JACKSON
ENVIRONMENT AND PLANNING
STRATEGY | INFRASTRUCTURE | COMPLIANCE | PROCUREMENT

Response to Submissions Report
Kariong Sand and Soil Supplies
Sand, Soil and Building Materials Recycling
Facility - SSD8660

Figure 6.3. Updated General Arrangement Plan.

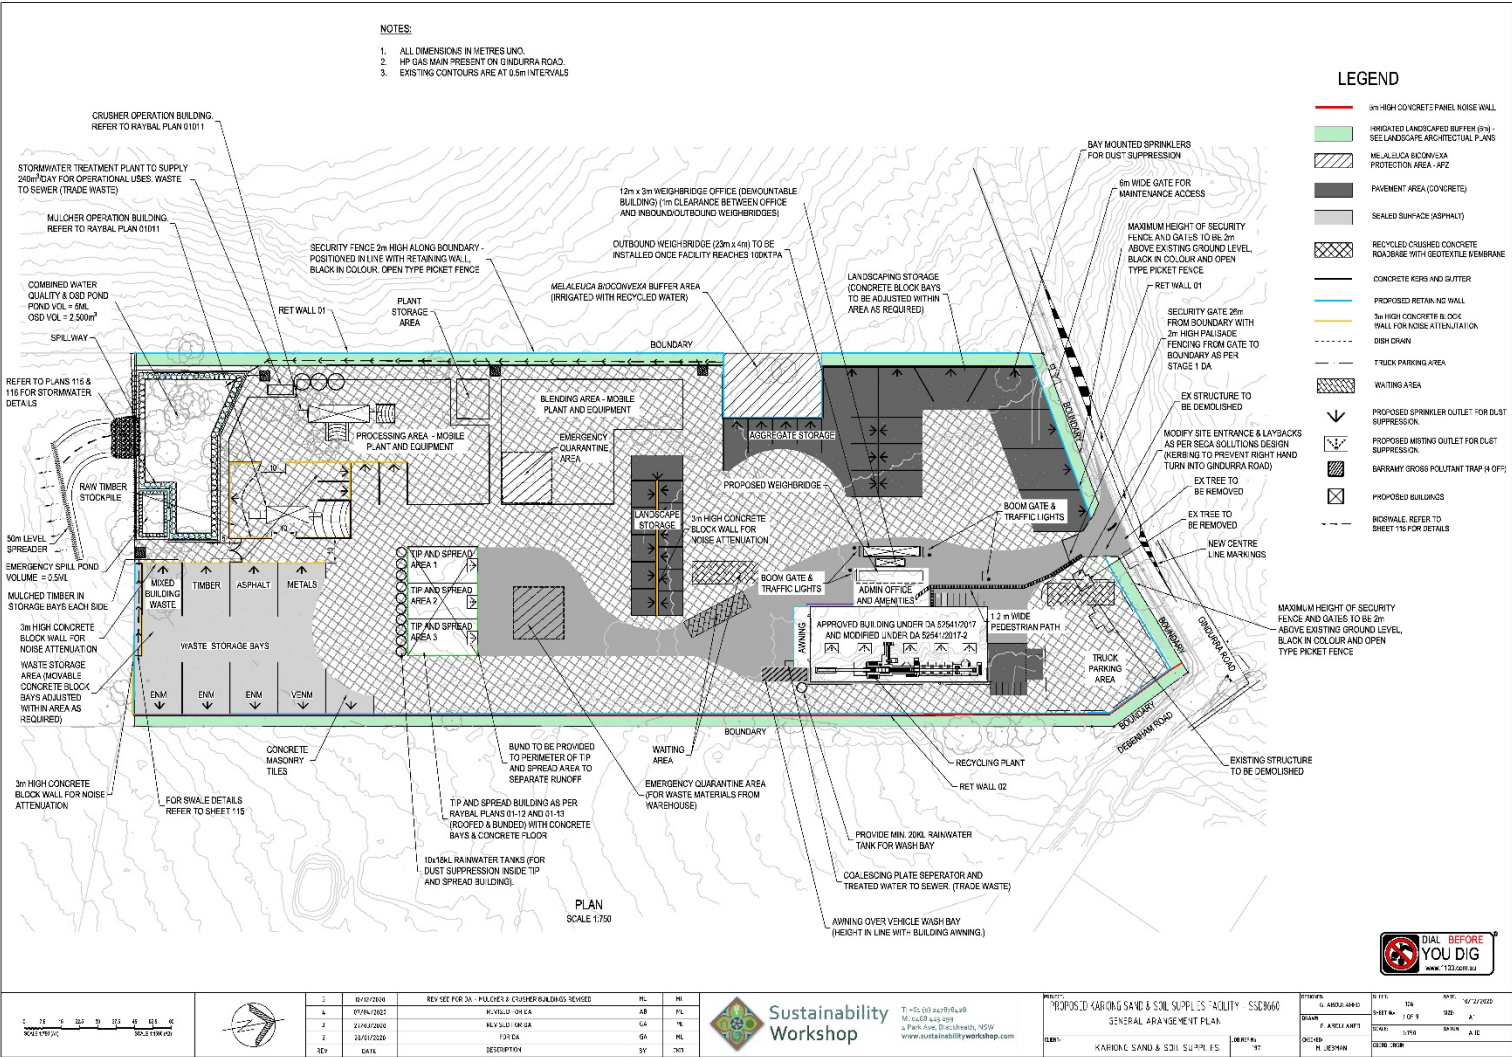
The changes to the plans and figures reflect the changes listed in the section above. Appendix 1 provides copies of the original General Arrangement Plan for before the changes and the final General Arrangement Plan for comparison. The full set of civil plans is provided as an appendix to the revised EIS.

- General Arrangement Plan – showing general site layout and key features
- Turning Path Plan – showing turning paths for large vehicles on-site
- Detailed Shed Plan – showing details of the Secondary Sorting Warehouse, including the sumps.
- Stormwater Plan – showing the proposed stormwater capture and drainage system
- Stormwater Sections & Detail – showing the design of the On-site Detention Basin, outlet weir and Bioswales
- Layout and elevation plans for Crusher Building
- Layout and elevation plans for Mulcher Building
- Layout and elevation plans for Tip and Spread Building.
- Hydraulic services plan.
